Pinon Mesa Rock Creek
Master Traffic Impact Study
PCD File No. P209
(LSC #184380)
March 2, 2021

LSC Responses to
EPC TIS Redline
comments on
this document

LSC RESPONSES TO EPC TIS REDLINE Comments

Figure 11: MUTCD Warrant 2, Four-Hour Vehicular Volume (Short-Term Baseline)

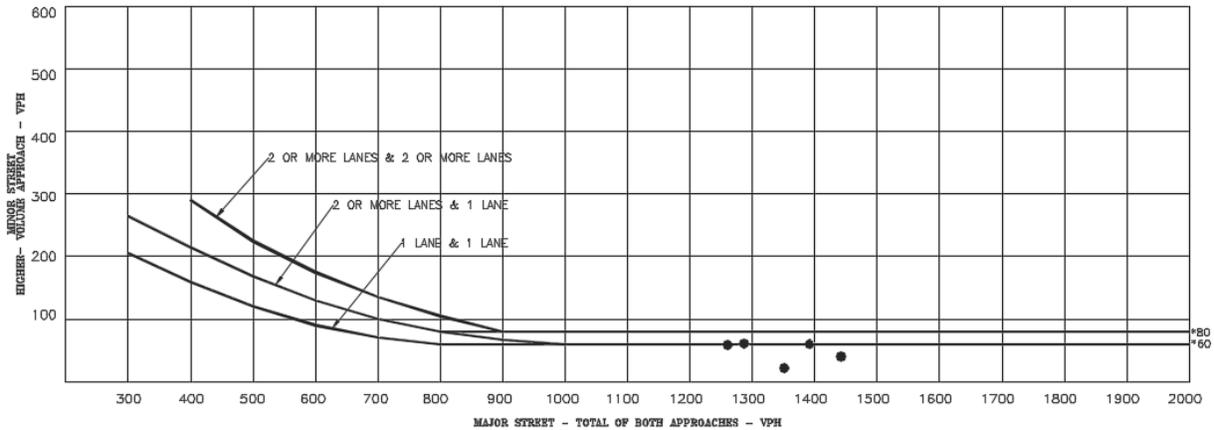
fix duplicate text

[fix duplicate text](#)

Author: jchodsdon Subject: Sticky Note Date: 5/2/2021 17:39:12
LSC Response: Duplicate text has been removed in the updated TIS report.

Author: jchodsdon Subject: Sticky Note Date: 5/2/2021 17:39:21
LSC Response: Duplicate text has been removed in the updated TIS report.

Table 3

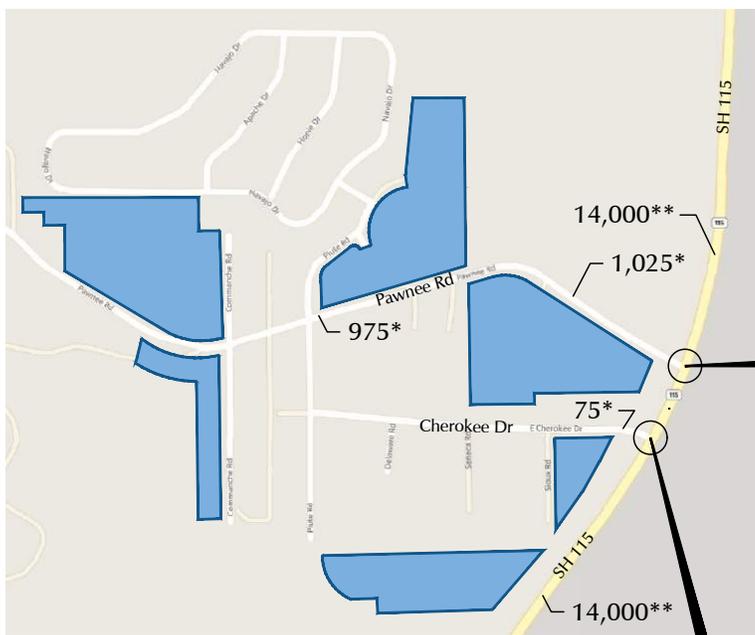
?

LSC Response: This divider page has been deleted as Table 3 is embedded in the report document rather than attached.

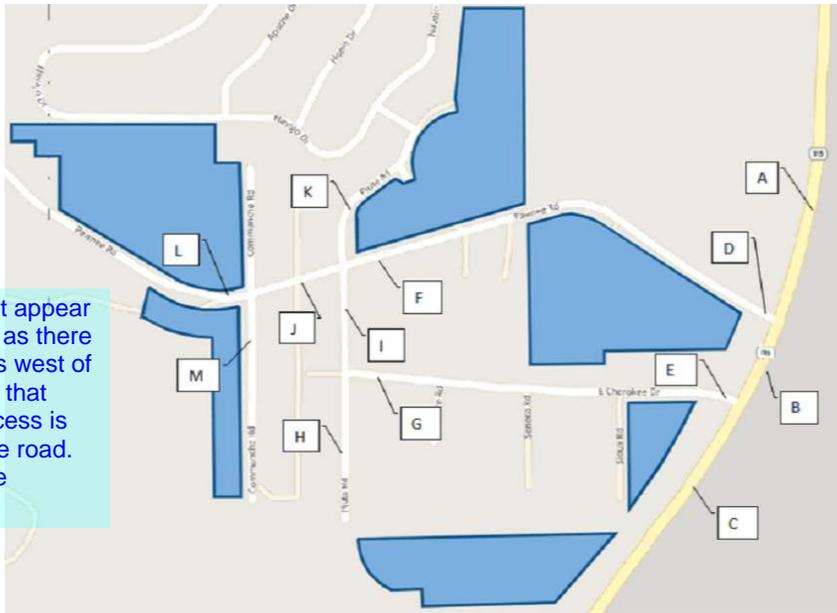
This does not appear to be correct as there are many lots west of Comanche that their only access is off of Pawnee road. Please revise accordingly

LSC Response: The ADT volume for call-out for location "L" has been corrected in the table (changed from 2 to 200 vehicles/day) to reflect the approximately 20 existing lots to the west of Comanche.
